5/16/89

A000094

REACH 1

Revisions :

STA. 614+00

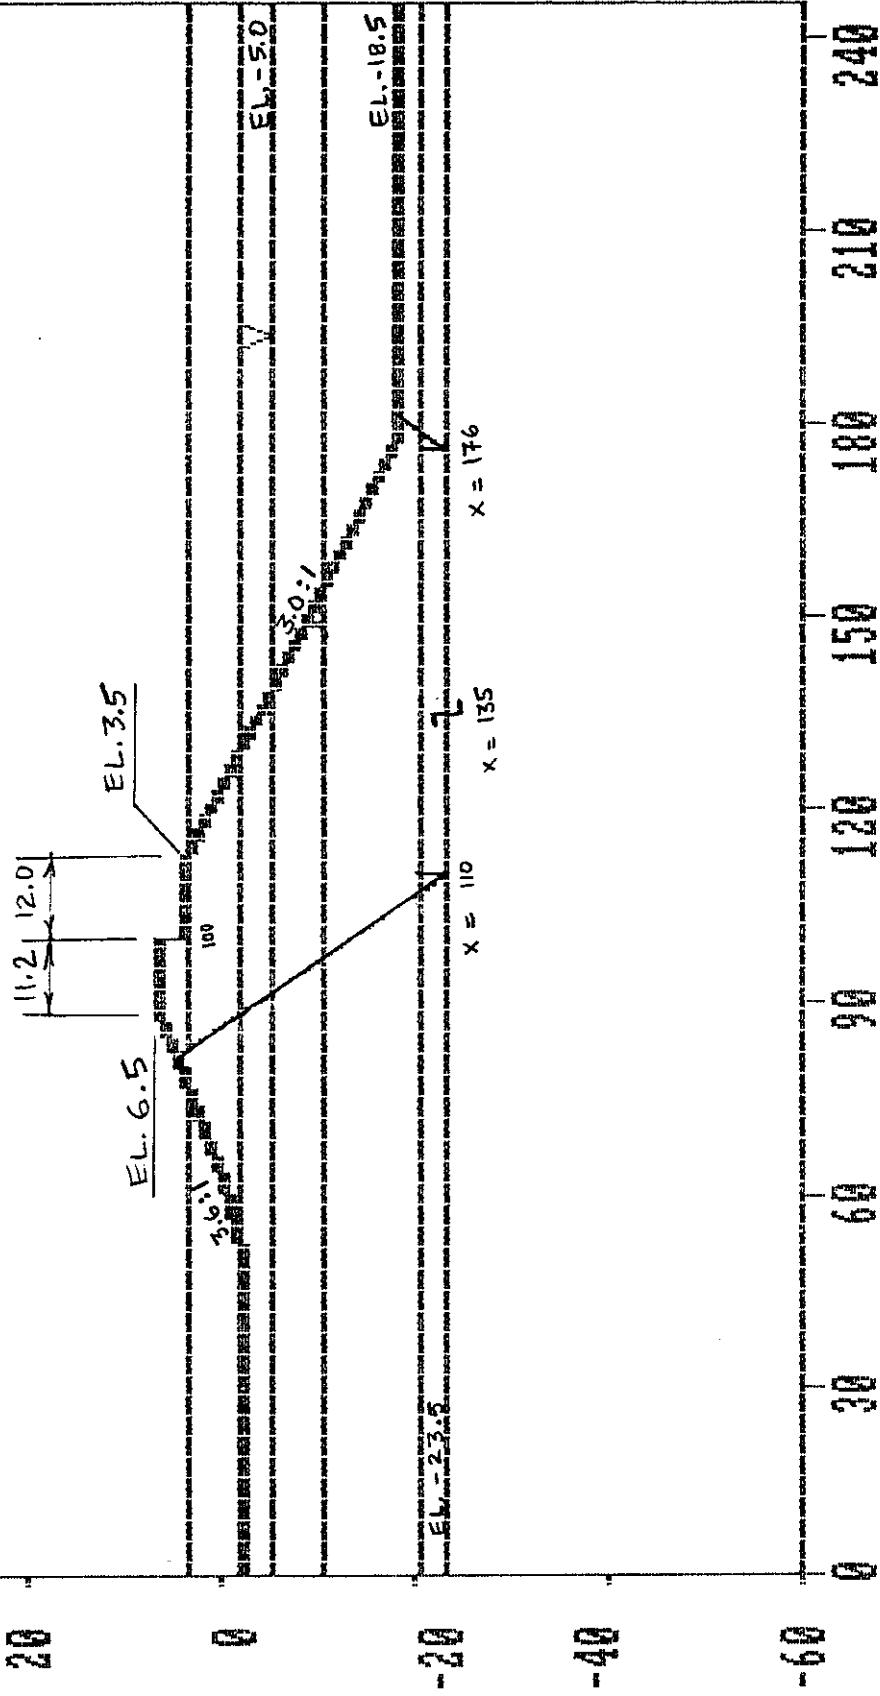
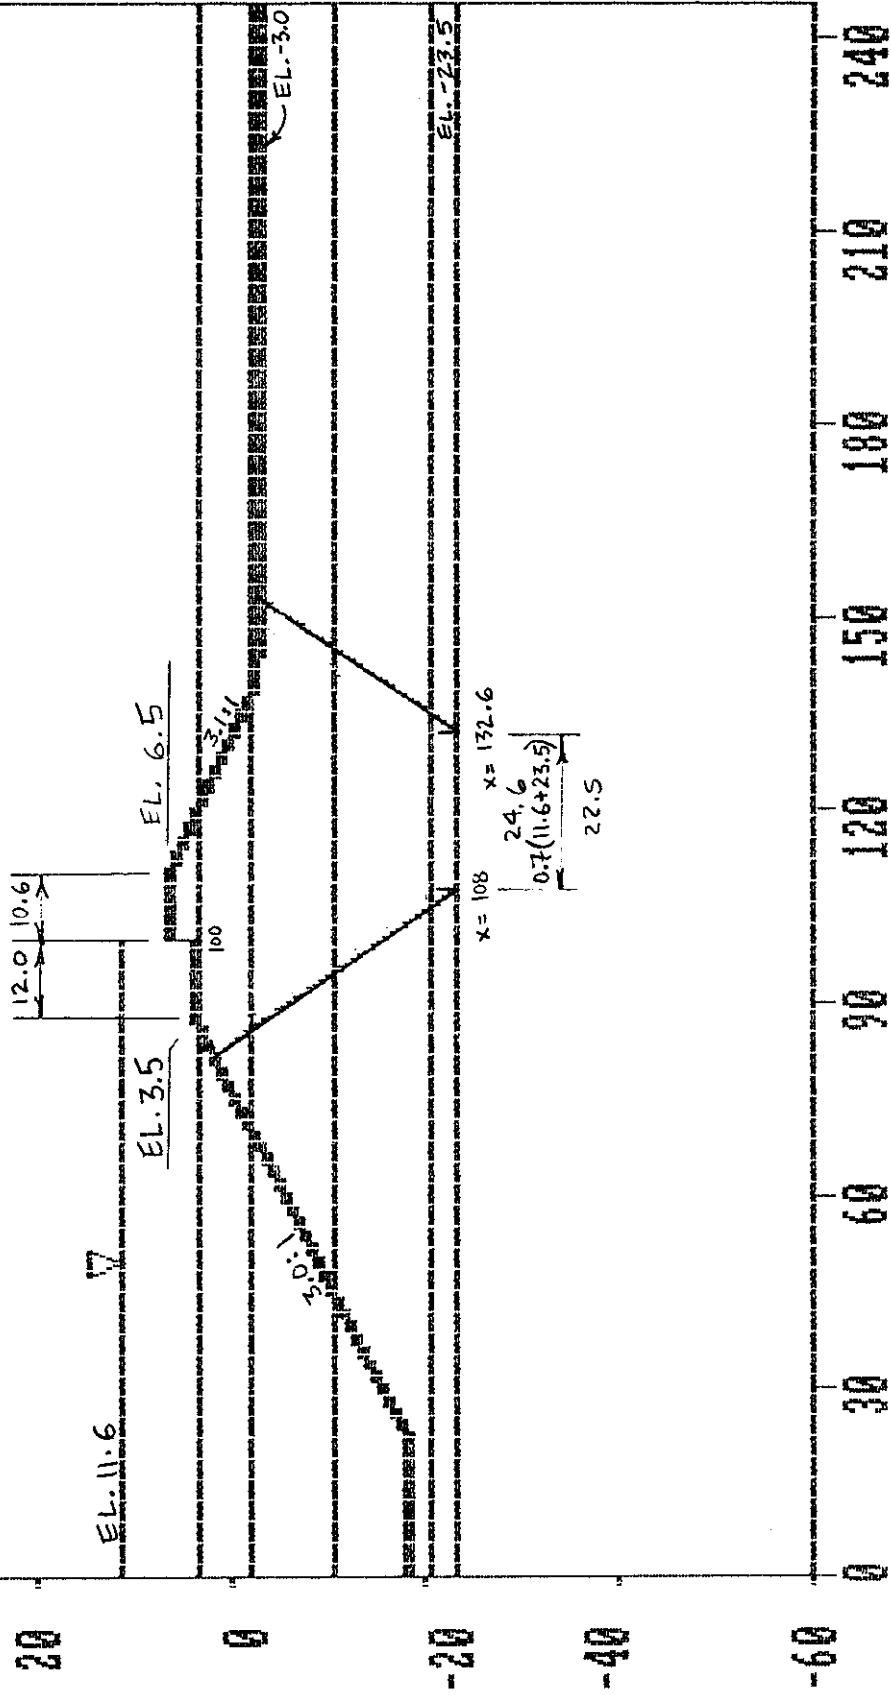
1. Entire sheet pile wall moved 0.5' closer to the canal thus increasing the crown width 0.5' along the entire reach.
2. Crown elevation lowered from El. 7.0 to El. 6.5 thus increasing the crown width an additional amount which depends on the backslope at each station.
3. Step elevation lowered from 3.6 to 3.5.
4. Step width increased from 9.0' to 12.0'.

1. New canalside stability analyses taking into account the above revisions, the correction to the soil shear strength from El. 0.0 to El. -2.0, and the piezometric headline of El. -2.4 in the sand.
2. New landside stability analyses taking into account the above revisions.
3. New sheet pile analyses taking into account the above revisions and the submerged canalside soil weight.

Canalside Failure - 614+00 and 616+00. The section at Sta. 614+00 governs.
*** Minimum Factor of Safety = 1.38 at El. -23.5 ***

Landside Failure - 616+00, 618+00, 620+00, 622+00 and 624+27. The section at Sta. 622+00 governs.
*** Minimum Factor of Safety = 1.37 at El. -23.5 ***

CANAL-SIDE FAILURE
STA. 627 +2.8

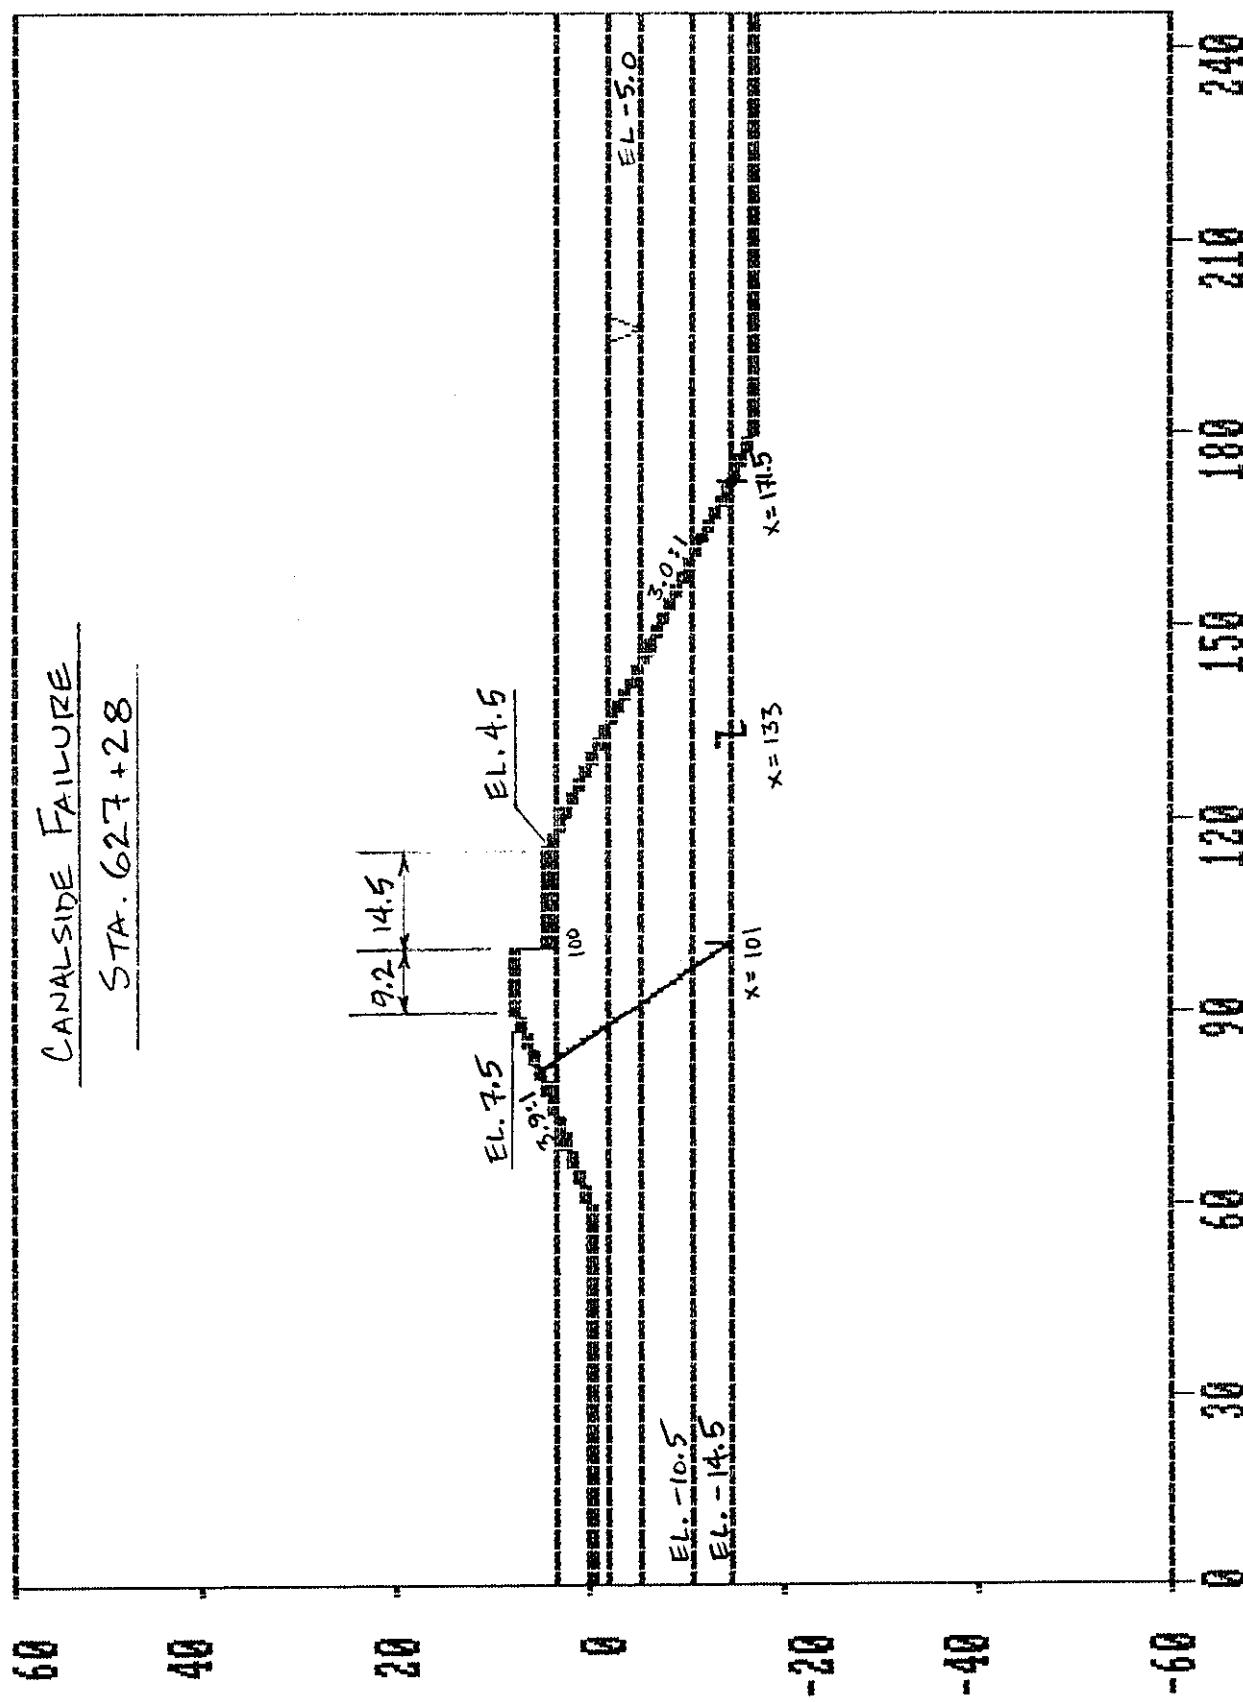
1. Step elevation lowered from 5.5 to 4.5.
2. Step width increased from 8.5' to 14.5'.

1. New canalside stability analyses taking into account the above revisions, the correction to the soil shear strength from El. 0.0 to El. -2.0, and the piezometric headline of El. -2.4 in the sand.
2. New sheet pile analyses taking into account the above revisions and the submerged canalside soil weight.

Canalside Failure - 627+28.
 *** Minimum Factor of Safety = 1.38 at El. -14.5 ***

STA 665 + 00

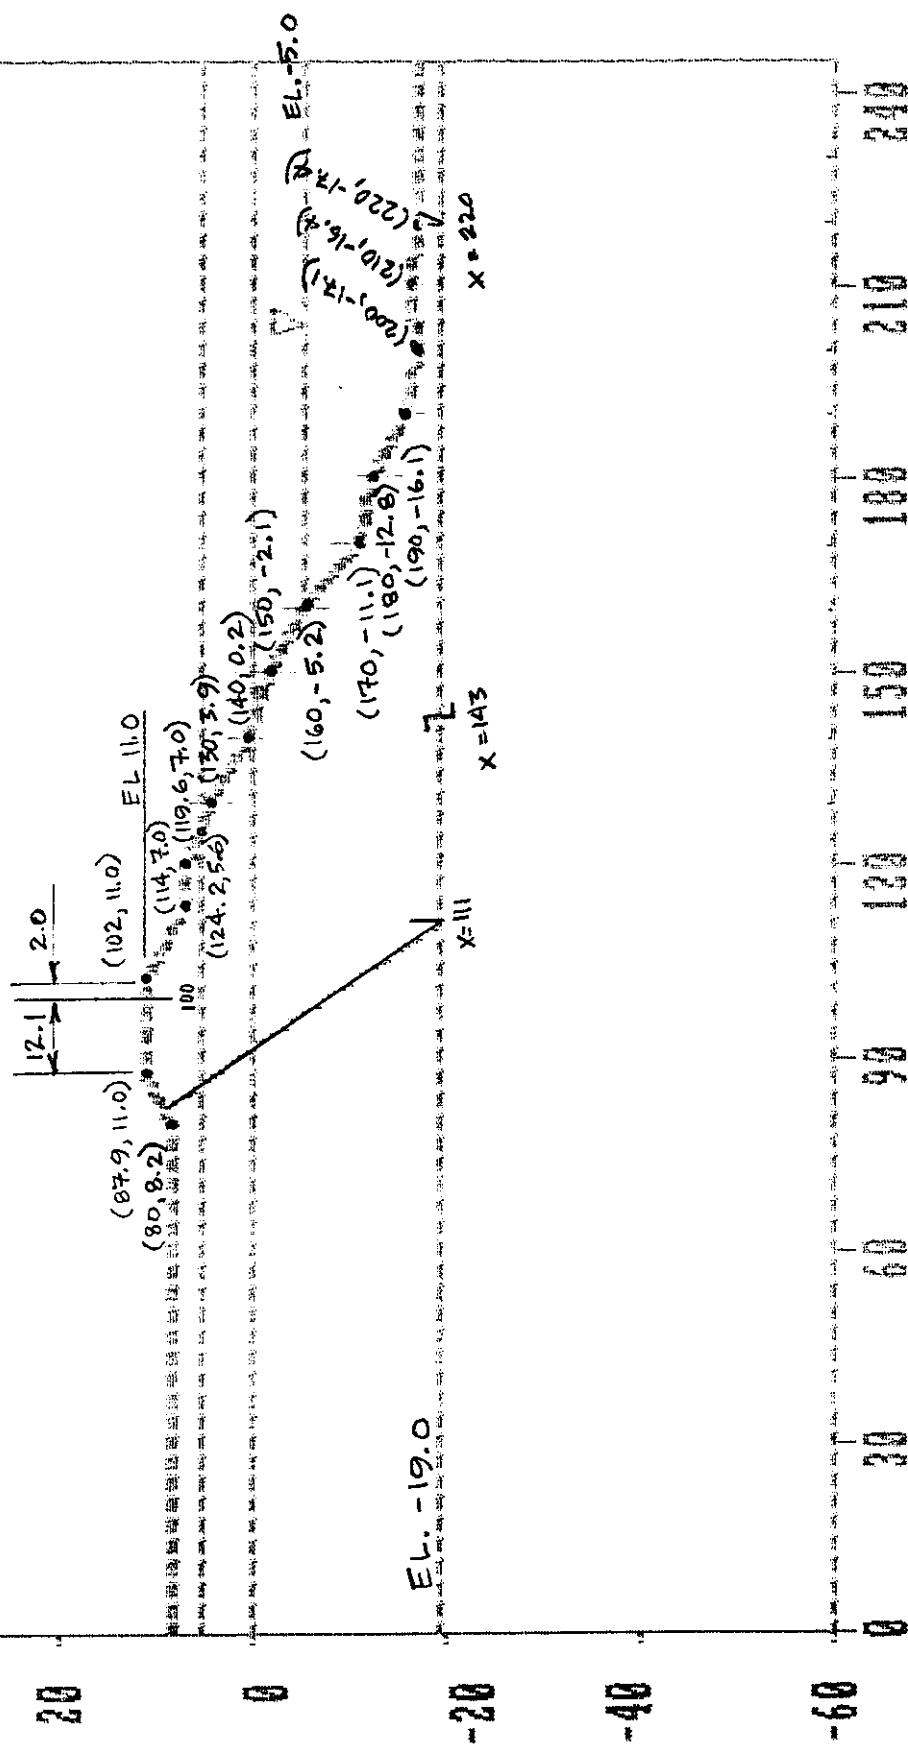
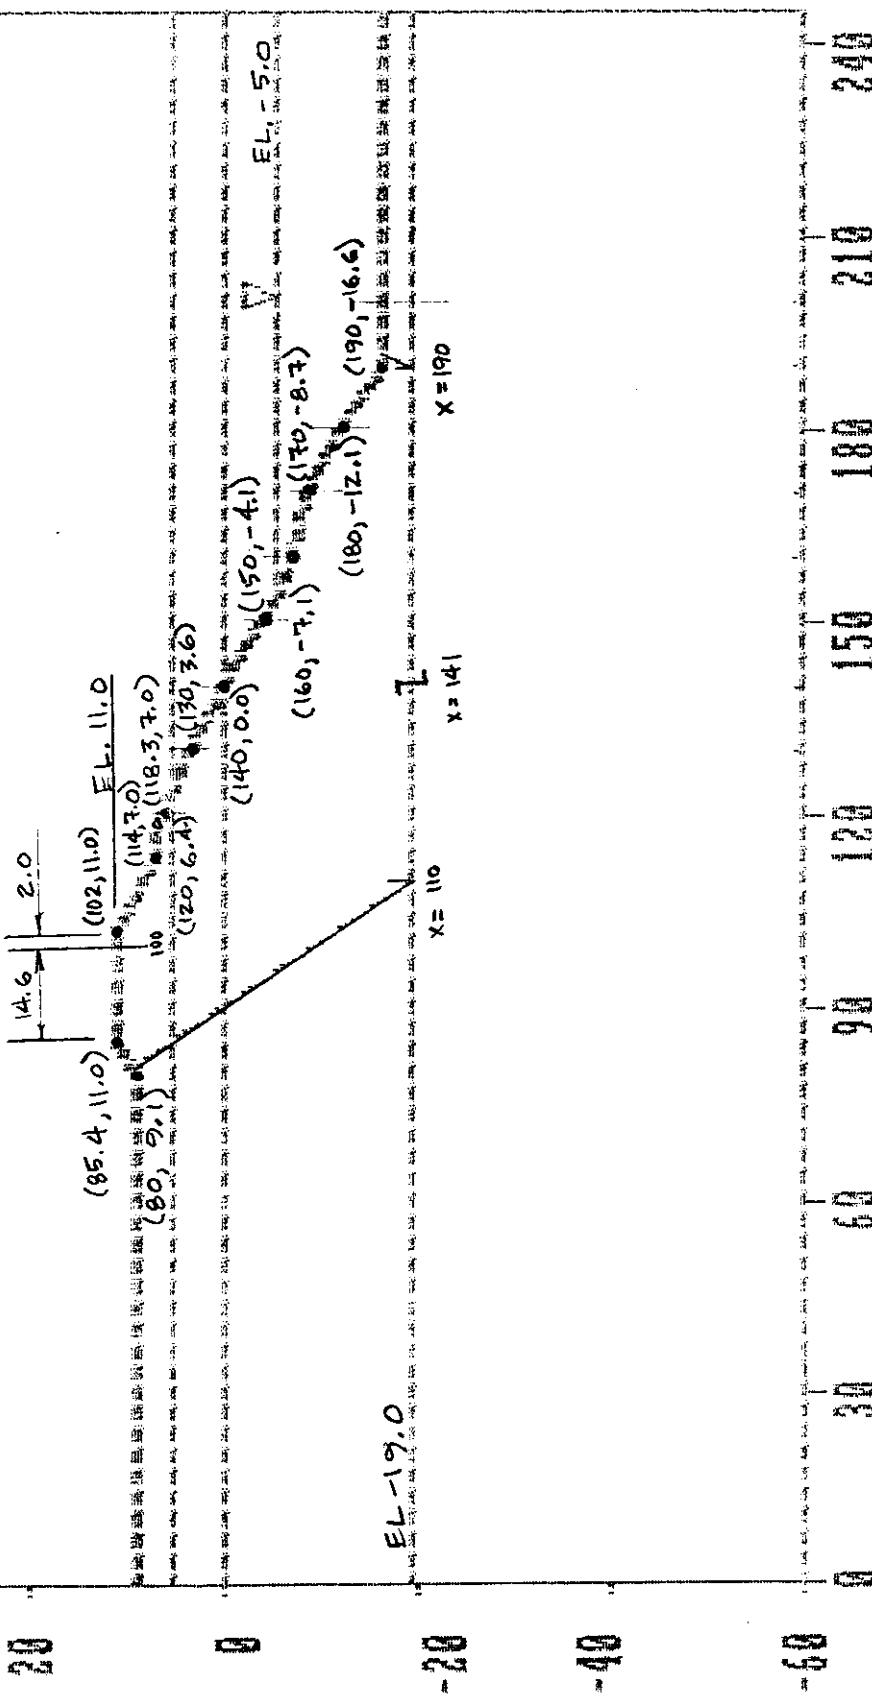
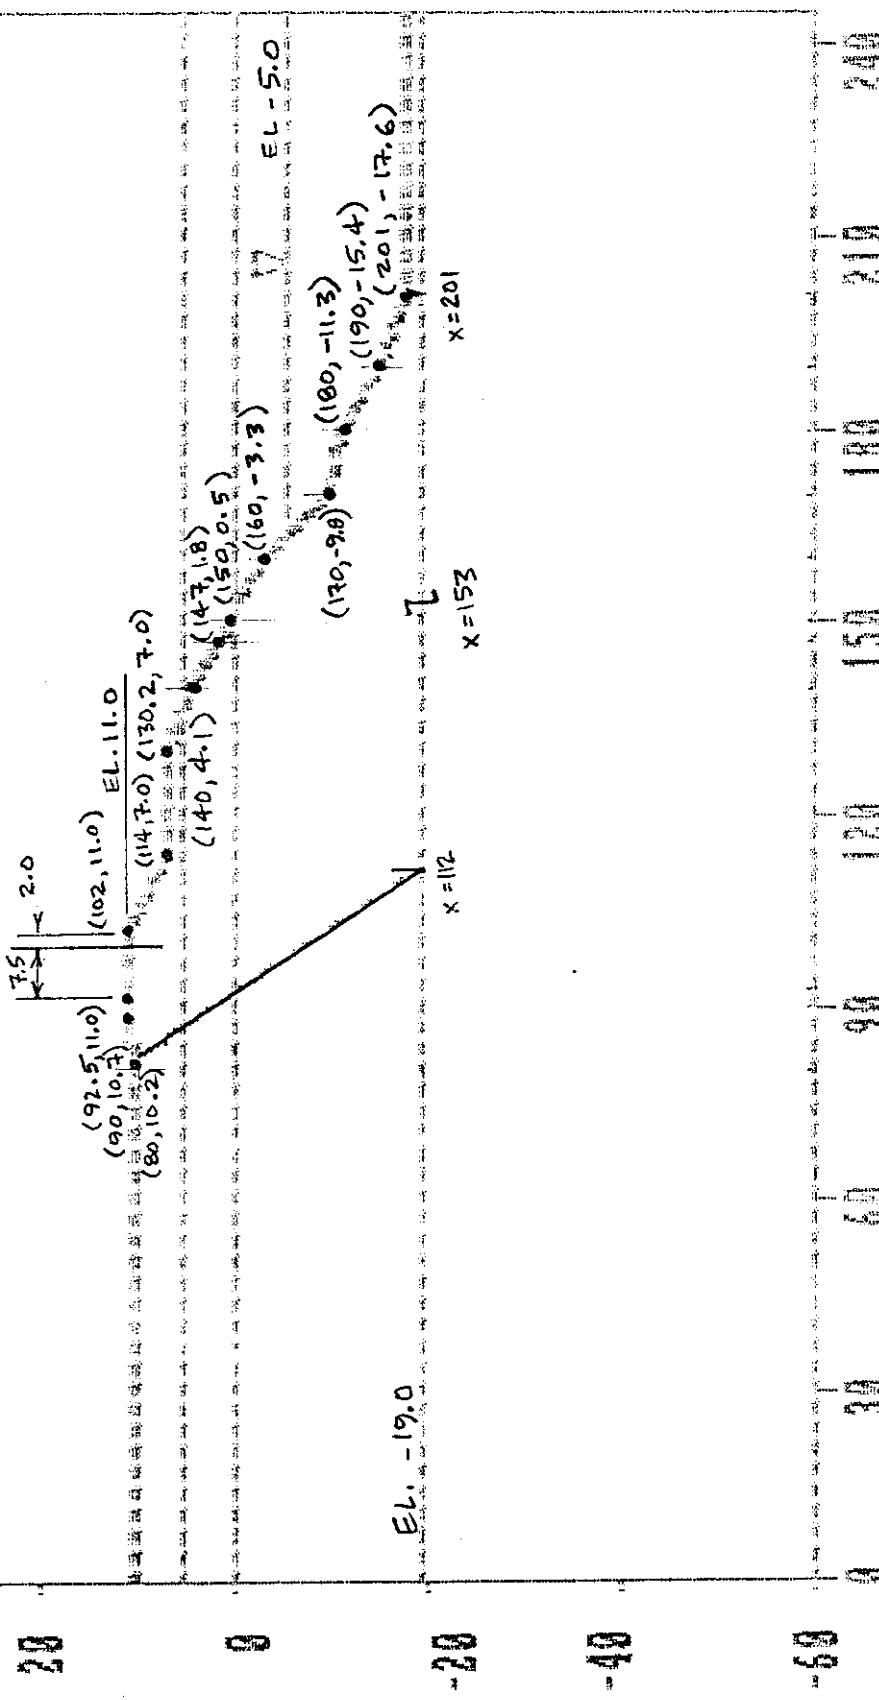
1. Sheet pile alignment changed.
2. Crown elevation lowered from El. 12.0 to El. 11.0.
3. Crown width behind the sheet pile wall changed from a constant 8.0' to a varying width between the sheet pile wall and El. 11.0 on the existing backslope.
4. Step elevation raised from El. 2.0 to El. 7.0.
5. Step width changed based on the above revisions.

1. New canalside stability analyses taking into account the above revisions and the piezometric headline of El. -2.4 in the sand.

Canalside Failure - All cross-sections were checked. The section at Sta. 665+00 governs.
***** Minimum Factor of Safety = 1.32 at El. -19.8 *****
